**Facilities Planning
& Management**
UNIVERSITY OF WISCONSIN-MADISON

Lakeshore Nature Preserve service entrance and road

Questions and answers

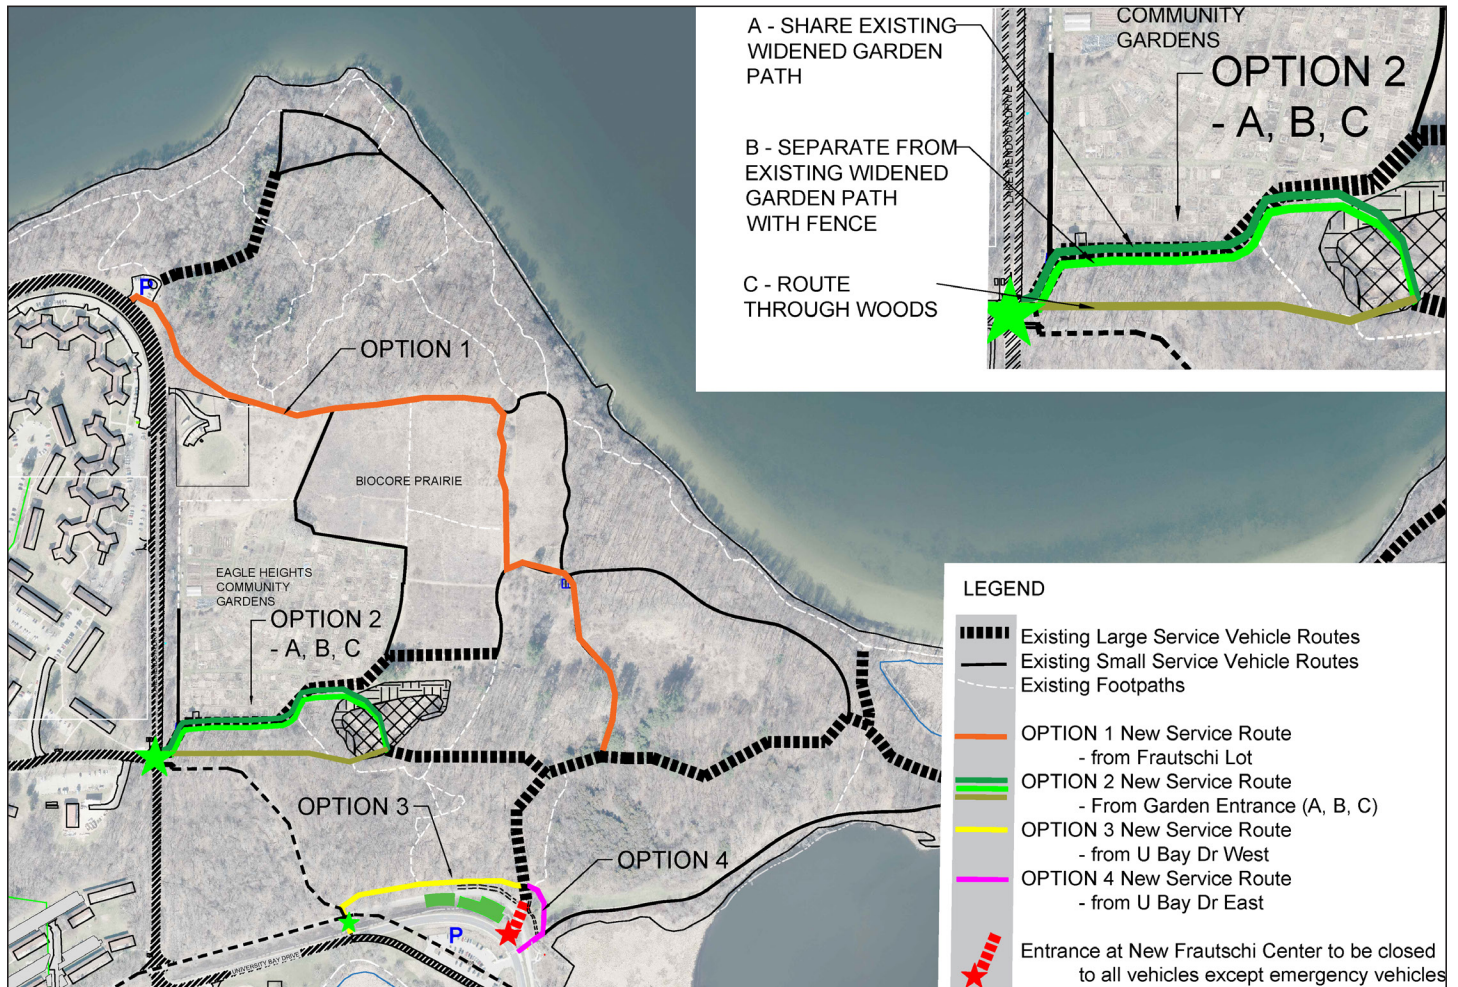
What is the design of the new service entrance, road and path?

Currently the proposed design specifies:

- The service road would be gravel and 14 feet wide. (The existing road is 9 feet wide.)
- It would be 860 feet from the entrance to its terminal at the campus maintenance yard.
- It would follow the current path of the garden road along the north edge (perimeter) of Bill's Woods, before turning into the campus maintenance yard. The road would not run through the woods.
- No lights are planned to be installed as part of this project.
- Speed limit signs are planned to be installed on the road.
- The proposed service entrance/road has been designed to have as minimal impact as possible (following the same path as the existing garden road, not cutting through Bill's Woods, not creating new roads where there are none, not adding to fragmentation).

- The gravel footpath would be 7 feet wide until it reaches the concrete weed pad, where it would remain 10 feet wide.
- To be improved: Erosion on the path heading north from the entrance and poor surface conditions on the path at the south edge of the gardens would be improved.

- There would be a 3-foot space between the road and footpath with gravel and a fence.
- The proposed fence would be chain link, installed 4 inches off the ground, so small wildlife could pass under it. Most birds would be able to fly over it, and deer would be able to jump over the fence.

Campus Maintenance Yard: Improvements

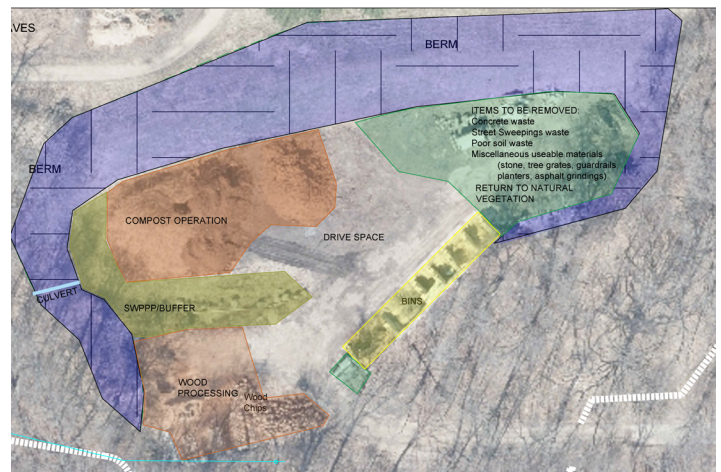
How are you improving the campus maintenance yard?

FP&M Physical Plant Grounds leaders are working closely with Preserve staff and others to begin removing items that can be recycled, reused, or disposed of. This work is scheduled to start by October 2026. Concrete waste, poor soil, and various usable materials that are currently stored in the yard will be removed, ultimately **shrinking the footprint of the yard**. The spaces that used to house the removed items will be returned to natural vegetation.

In addition, planning is underway to rethink what landscaping materials are critical and what can be relocated.
